File Number	PL 21-187	Contact	John Kelley	
Type	HE-O Planning Review	Planning Commission Date	December 14, 2021	
Deadline for Action	Application Date	November 9, 2021	60 Days	January 8, 2022
	Date Extension Letter Mailed	November 29, 2021	120 Days	March 9, 2022
Location of Subject	West Arrowhead Road east of Kenwood Shopping Center			
Applicant	Shamrock Management LLC	Contact		
Agent	Scalzo Architects Ltd.	Contact		
Legal Description	010-2640-03650, 010-0145-00020, part of 010-2640-01780, part of 010-2640-03295			
Site Visit Date	November, 2021	Sign Notice Date	November 30, 2021	
Neighbor Letter Date	December 3, 2021	Number of Letters Sent	63

Applicant proposes to construct a 12,000 sq. ft. commercial/office structure in the Higher Education Overlay (HE-O) with associated parking, landscaping, lighting, and connectivity located to the north and east of the Kenwood Shopping Center, adjacent to Arrowhead Road.

PROJECT:
ARROWHEAD CENTER
1218 WEST ARROWHEAD RD
DULUTH, MINNESOTA 55811

PLANNING REVIEW FOR
HIGHER EDUCATION OVERLAY
NOVEMBER 9, 2021

SHEET NO.
Z1.0

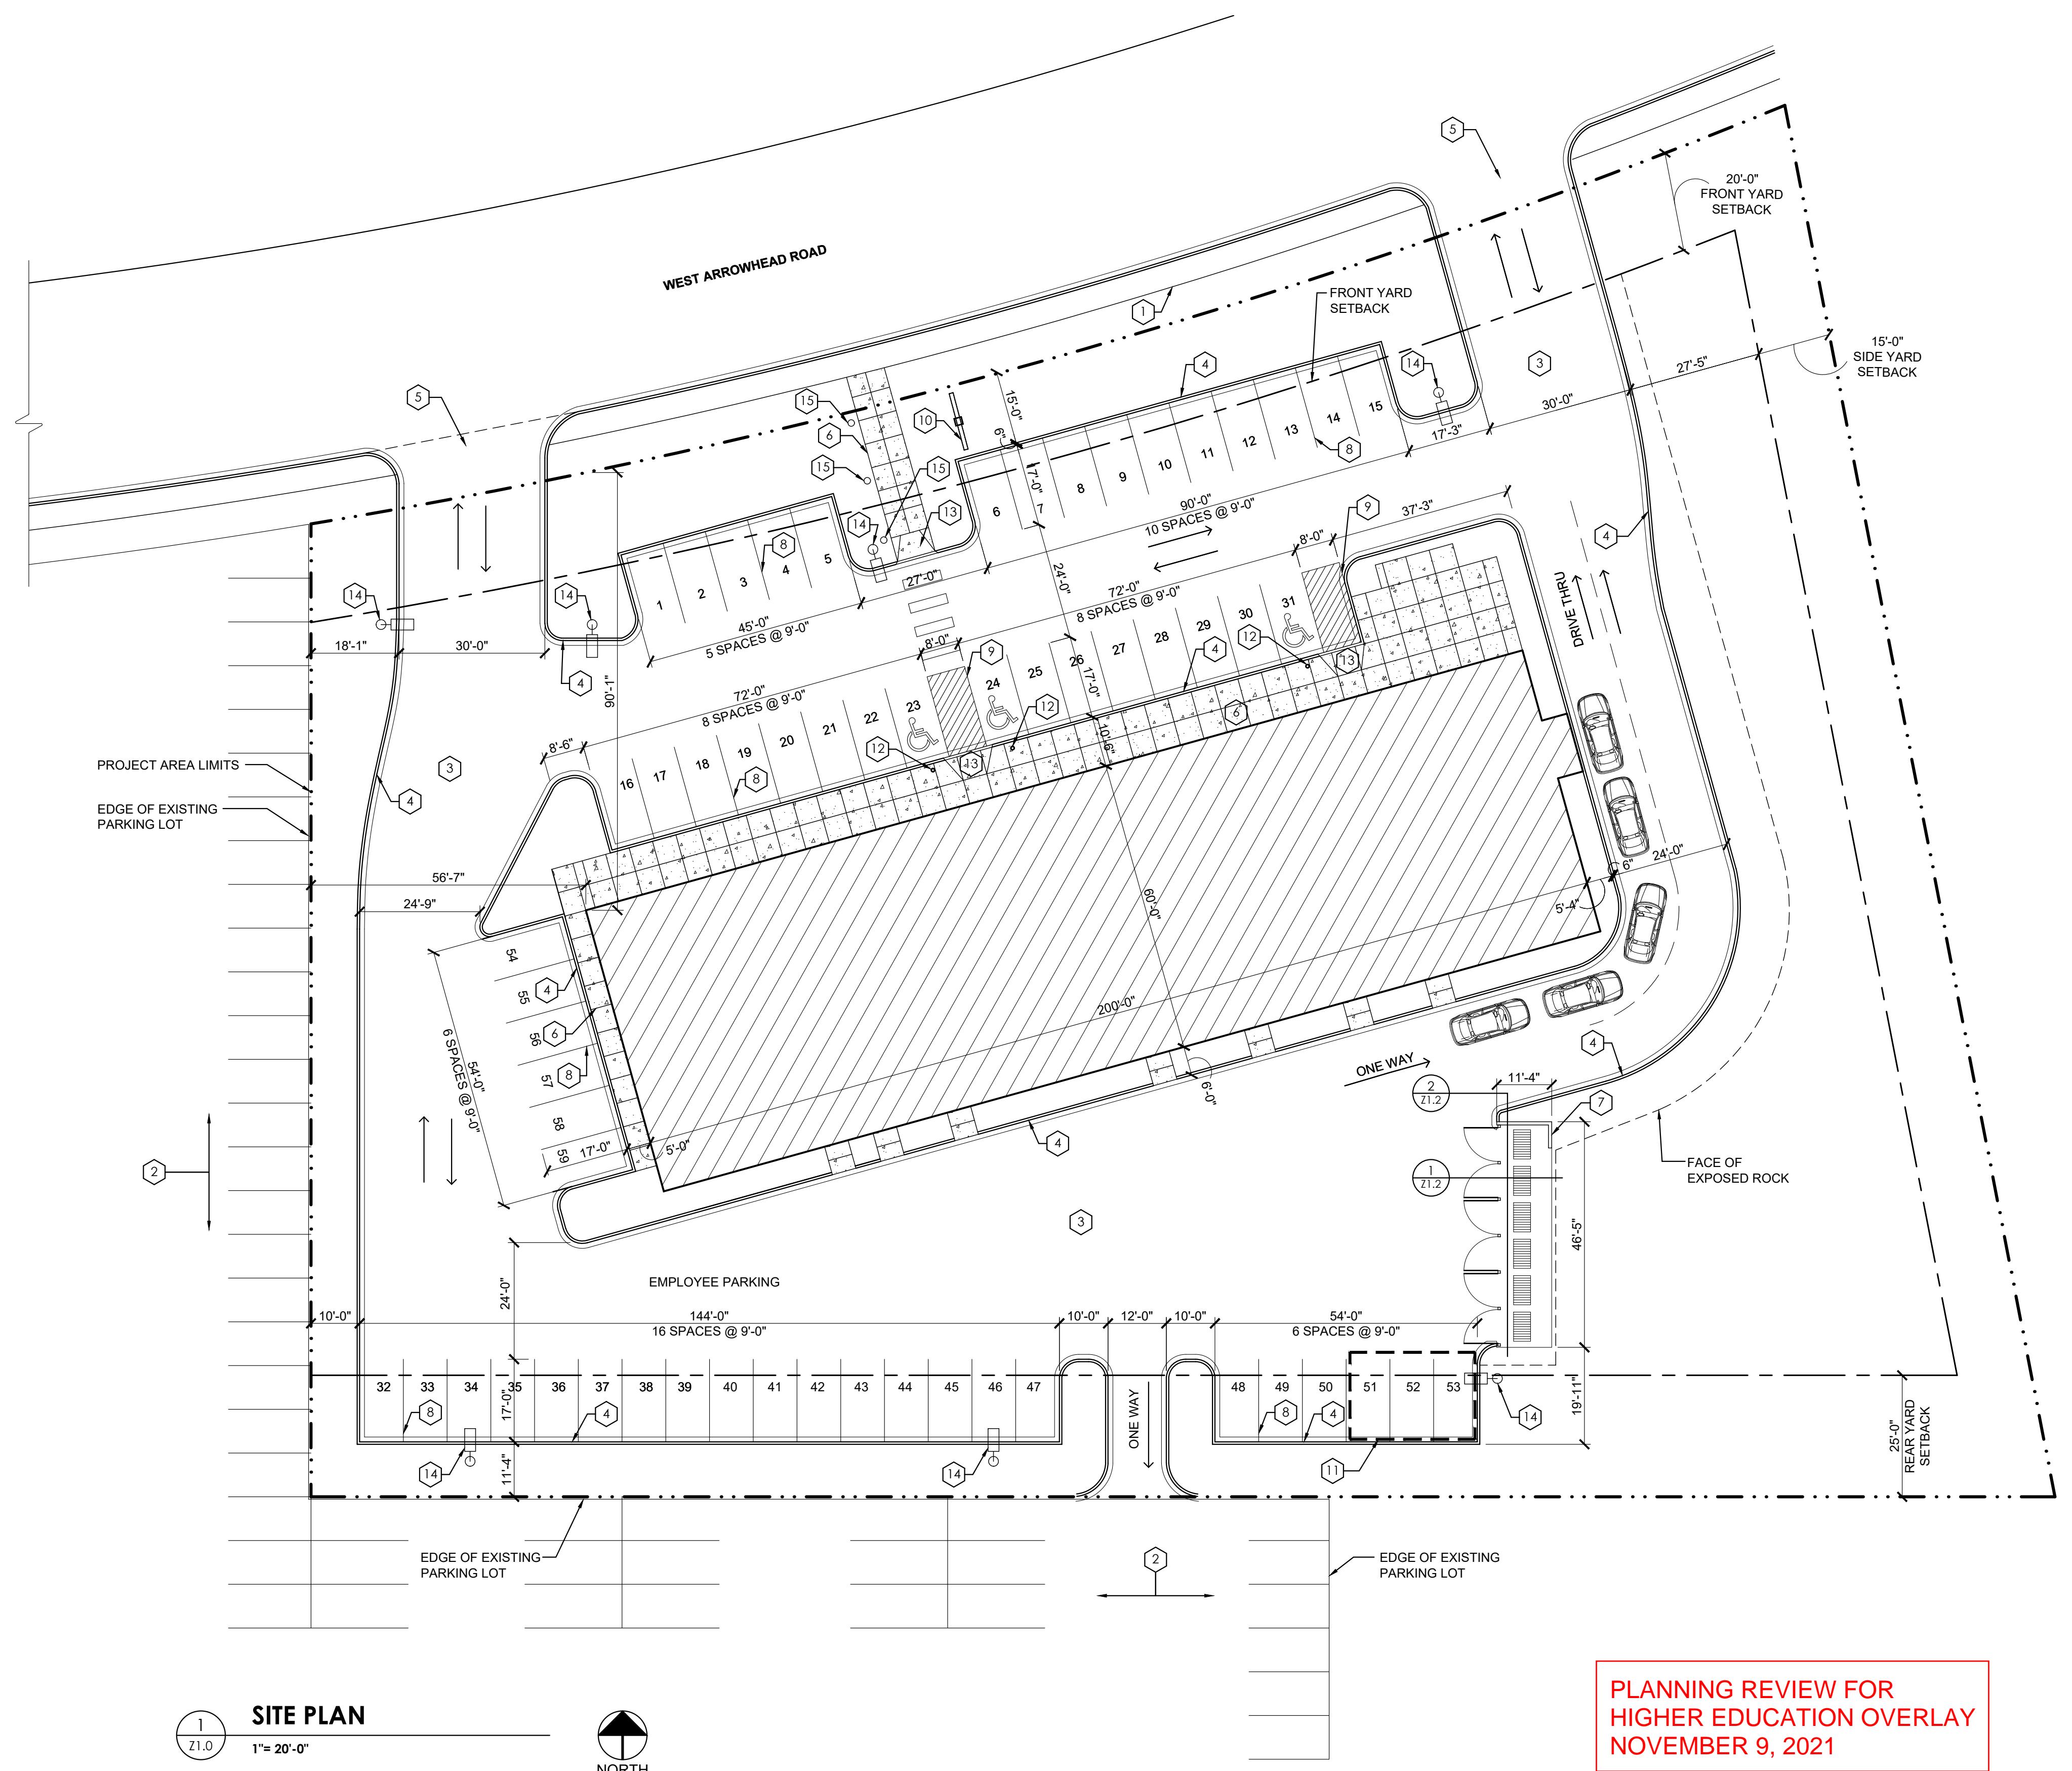
- 1) 50-18.5 (Higher Education Overlay Planning Review) – The applicant is proposing to construct a 12,000 square foot commercial/office building along West Arrowhead Road adjacent to the Kenwood Shopping Center. The property is zoned Mixed Use Neighborhood (MU-N) but is within the Higher Education Overlay (HE-O) district, which requires a planning review by the planning commission. This overlay district has additional development standards to the underlying zoning requirements.
- 2) 50-18.5.C (HE-O Development Standards) – Access to the site will be gained via two curb cuts along West Arrowhead Road. The site plan depicts a drive-through window and lane located on the east side

of the building. The HE-O requires primary buildings be constructed to a build-to zone of five feet to 20 feet along a primary street such as West Arrowhead Road. However, if the Land Use Supervisor (LUS) determines that site conditions such as topography or physical features on the property make the build-to zone requirement unfeasible (see UDC Section 50-18.5.C.1.b), an alternative building location may be considered if certain site design features are incorporated into the development. The LUS has determined that site conditions including lot configuration, exposed rock, and building layout are not conducive to the build-to zone requirement. The applicant has submitted a site plan incorporating the required alternative design elements, as follows:

- Eight foot wide concrete walkway connecting to existing sidewalks along West Arrowhead Road.
- Painted crosswalk between main entries to building and parking area – The applicant has noted that the crosswalk within the parking area is designed for drainage to the curb along the north side of the parking lot. There is a catch basin located directly adjacent to the east of the pedestrian walkway and a catch basin located approximately 45' to the west of the pedestrian walkway to remove water from the parking lot. The potential for ponding water is eliminated for the striped crosswalk.
- Pedestrian-scaled lighting – The site plan shows pedestrian-scale light along the west side of the walkway between the sidewalks on Kenwood Avenue and the parking/front of the building.

- 5) 50-20.2.Q (Use Specific Standards) – The site plan depicts a drive through window and lane on the east side of the building adjacent to a lot with a residential structure. In the MU-N Zone district drive-through lanes and windows have specific performance standards that apply to for that use, due to its potential for noise, lighting, or other visual impacts to adjacent properties. The proposed drive-through window hours of operation may be affected by the proximity to the adjacent residential structure to the east. The landscape plan proposes screening of the adjacent residential structure to the east with trees and shrubs. If appropriate, the Planning Commission may further evaluate whether installation of a fence along the east property line is necessary to mitigate glare and noise from cars in the drive-through lane and stacking spaces.

- 6) 50-23 (Connectivity) – West Arrowhead Road is considered a primary street in the HE-O district. Public sidewalks exist along West Arrowhead Road. The site plan shows a pedestrian walkway connecting from the building main entries to the sidewalks. The site plan also depicts a one-way drive lane connecting to the adjacent parking area on the south side of the development. These connections will improve the development's pedestrian connectivity and allow for a vehicular connection to the Kenwood Shopping Center.

- 7) 50-24 (Parking) – The applicant is proposing 9,000 square feet of retail space which requires 27 parking spaces and 3,000 square feet of restaurant space which requires 20 parking spaces. The minimum number of required parking spaces is 47, and the maximum number of parking spaces is 70. The site plan shows 59 parking spaces along the north, west and south side of the building. Section 50-24.6.C allows for up to 60% of off-street accessory parking within the front yard if a pedestrian walkway is provided. Plans show a pedestrian walkway meeting the requirements for the front yard parking allowance.

- 10) 50-27 (Signs) – The site plan shows a proposed pole sign along the frontage on West Arrowhead Road. The landscape plan shows the shrubs at the base of pole sign as required. The proposed pole sign will require a separate sign permit.

- 12) 50-30 (Design Standards) – The building elevation drawings submitted meet the required design standards.
- 13) 50-31 (Exterior Lighting) – The site plan shows a number of LED light poles around the edges of the parking areas. The applicant will need to submit a lighting plan for review and approval.

Based on the above findings, staff recommends that Planning Commission approve the Planning Review, subject to the following conditions:

- 1) The project be limited to, constructed, and maintained according to the construction and building plans submitted with this application titled “Arrowhead Center.”

- 6) The final lighting plan shall be submitted and reviewed for approval in advance of building permit submittal, and shall be approved by the LUS.
- 7) Any alterations to the approved plans that do not alter major elements of the plan may be approved by the Land Use Supervisor without further Planning Commission; however, no such administrative approval shall constitute a variance from the provisions of UDC Chapter 50.

SHEET NO.
Z1.1

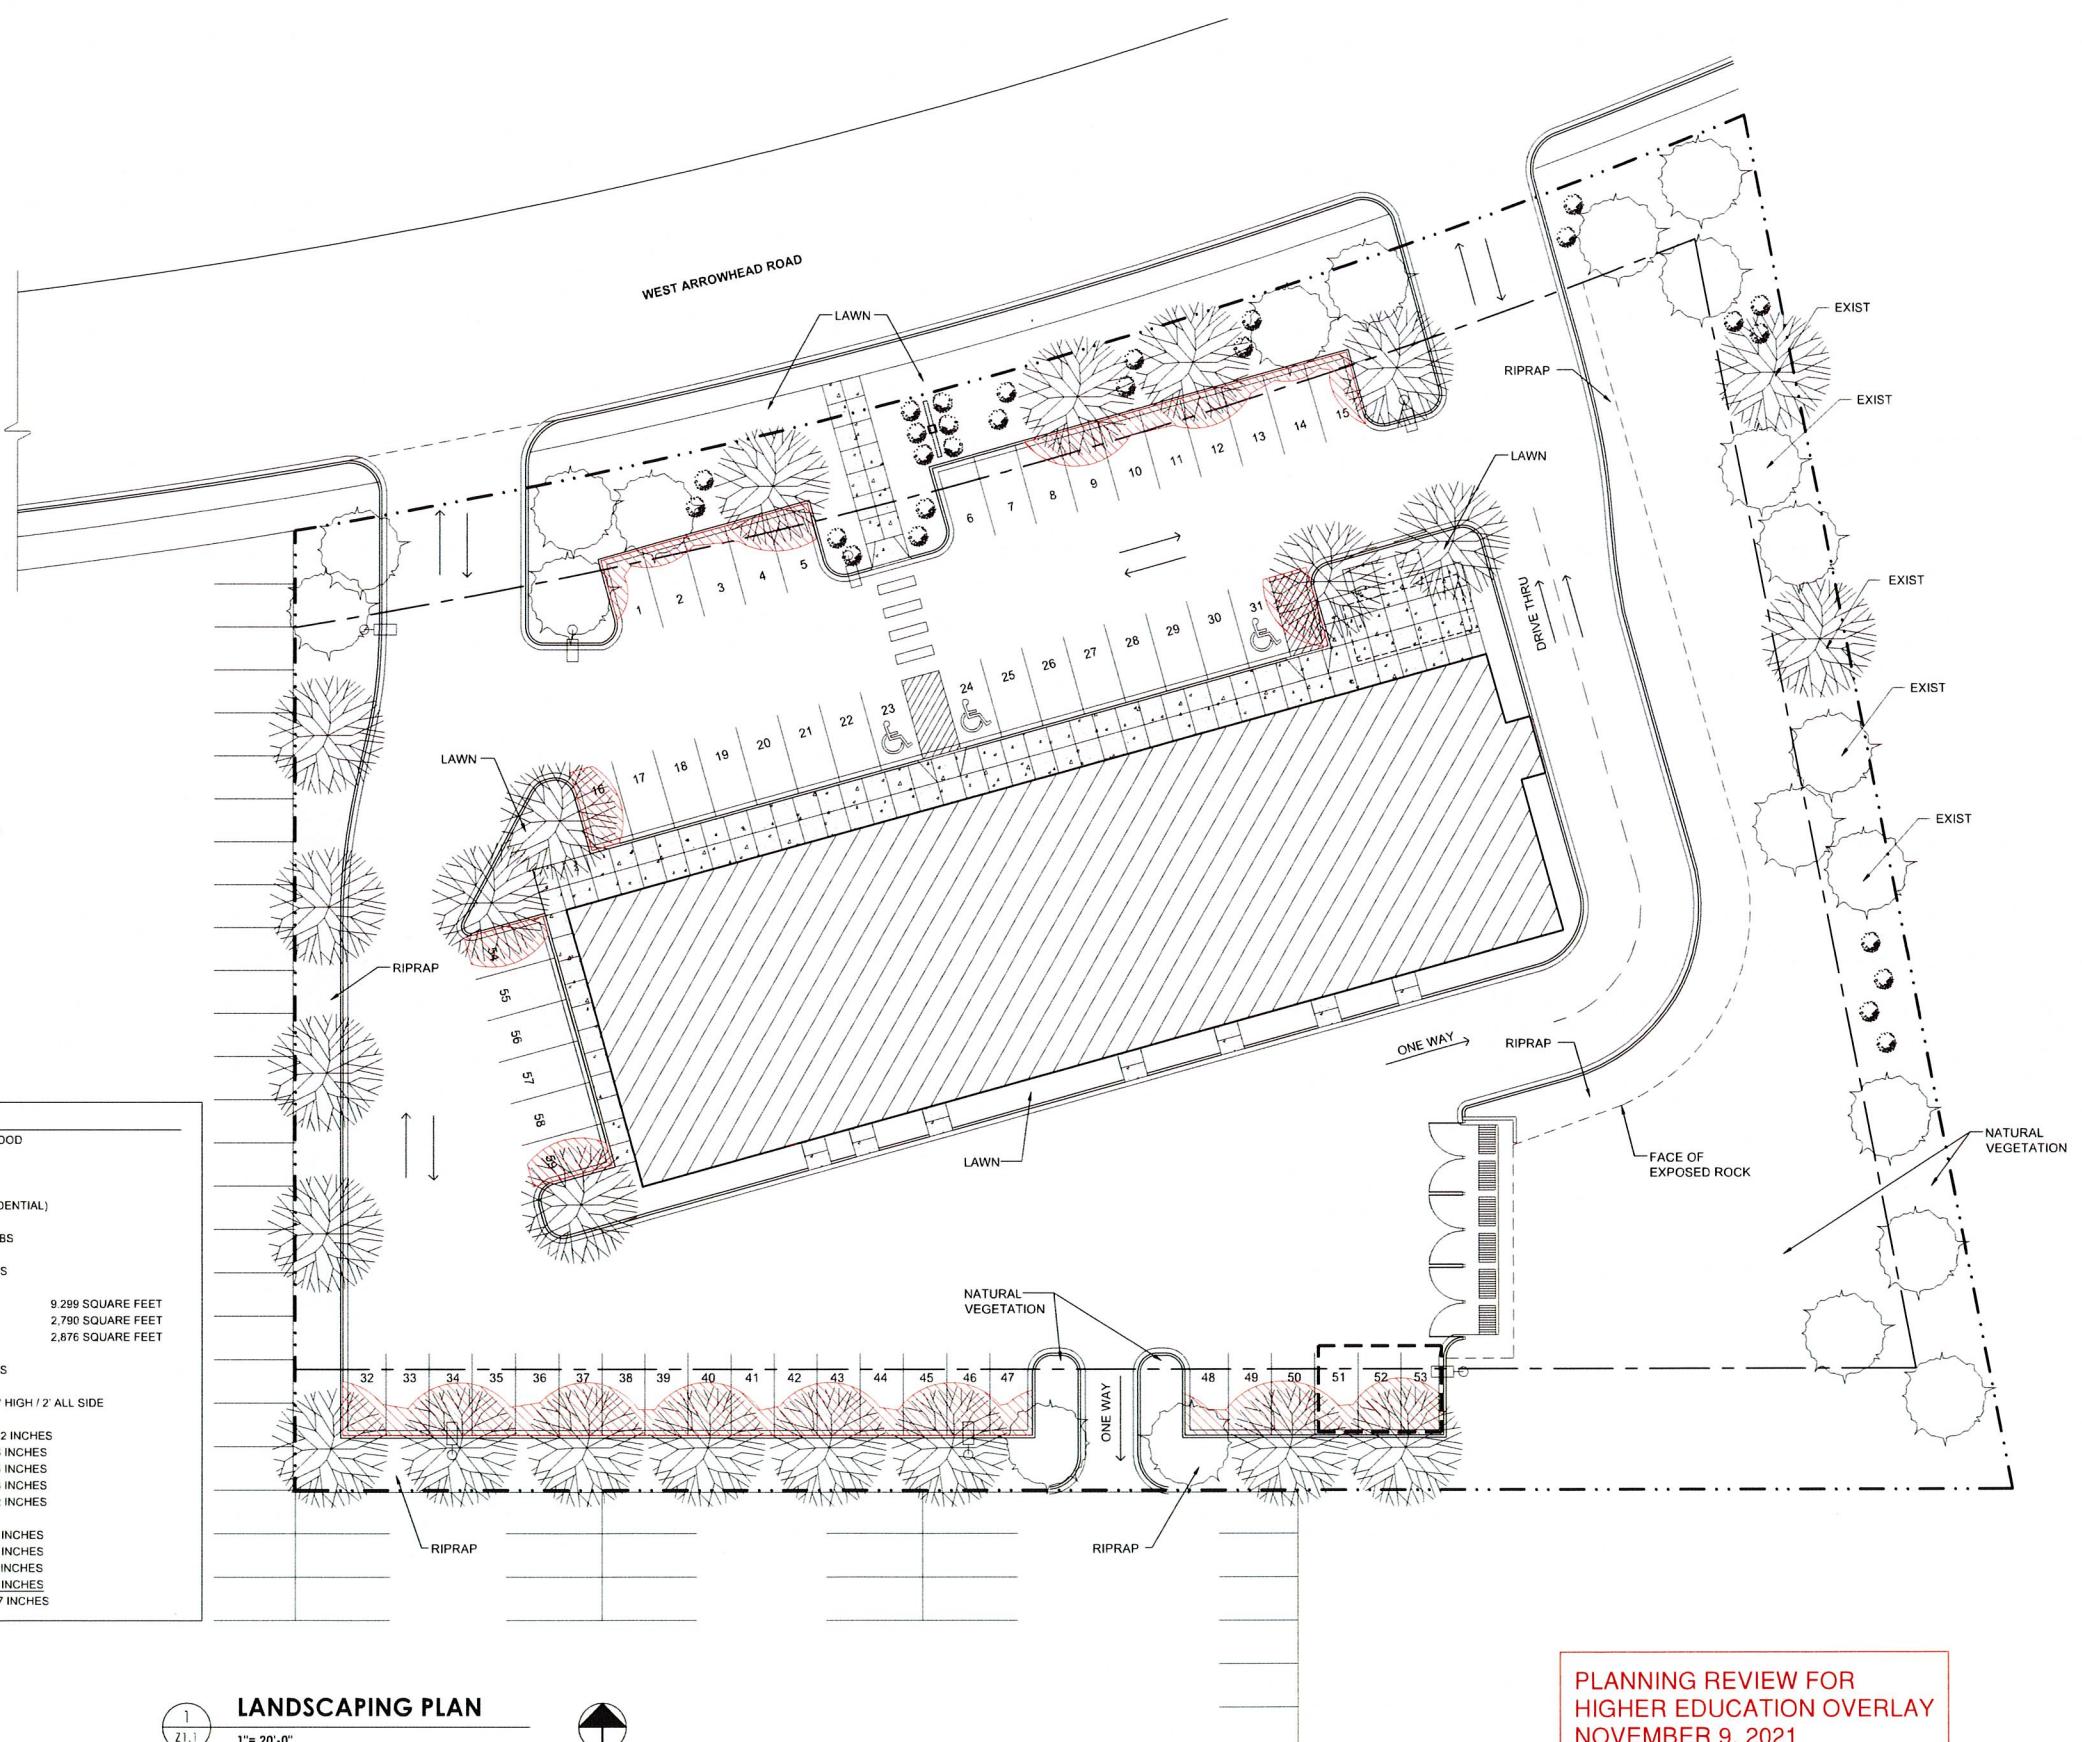
- 8) 50-25 (Landscaping) – The landscape plan indicates compliance with street frontage landscaping requirements. The applicant has calculated 31% canopy coverage at maturity for trees around parking areas and a vegetated buffer along the east property line is shown consisting of trees and shrubs to screen the development from the adjacent residential structure. Additional tree plantings are shown on the site plan to satisfy the tree preservation/replacement component of the site. Tree removal for the proposed development area of the lot occurred prior to the submittal of the planning review application. The City is working with the property owner to satisfy additional tree replacement requirements for the south and east portions of the lot. Conditions are recommended related to this

Planning Review to ensure timely compliance with all tree planting requirements.

- 2) Prior to issuance of building permit, Applicant shall submit a financial security in the form of a cash escrow or Letter of Credit in the amount of 100% of the installed value of the landscaping to insure survivability of all required landscaping for at least one year after installation.

- 3) Applicant shall comply with all tree replacement requirements as established in the May 17, 2021 letter from the City of Duluth (attached).
- 4) Applicant shall submit stormwater management plans prior to issuance of building permit.
